**CITY OF NAPLES
PURCHASING DIVISION
CITY HALL, 735 8TH STREET SOUTH
NAPLES, FLORIDA 34102
PH: 239-213-7100 FX: 239-213-7105**

ADDENDUM NUMBER 2

NOTIFICATION DATE:	BID TITLE:	BID NUMBER:	BID OPENING DATE & TIME:
02/29/12	Well Head Improvements	029-12	03/14/12 2:00PM

Well 418:

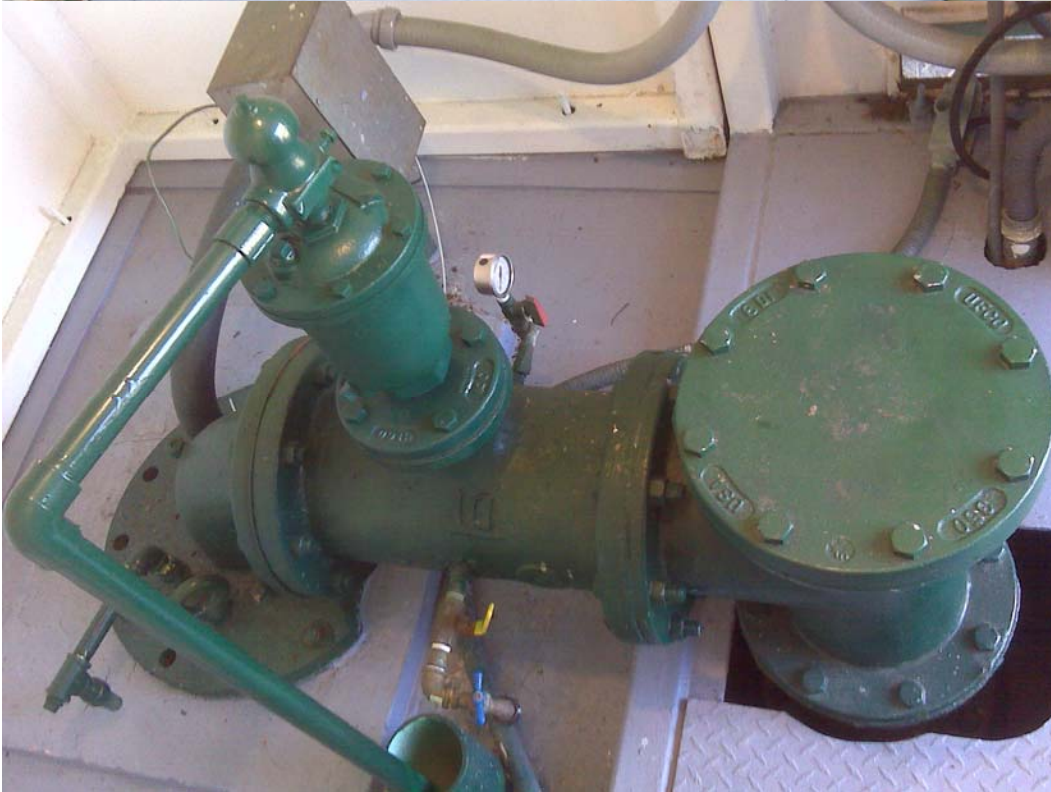
- 3) Existing well piping is 6" stainless steel flange-flange and may be in 10' or 20' sections.
- 4) The existing check valves and meters will be reused or new will be provided by the City.
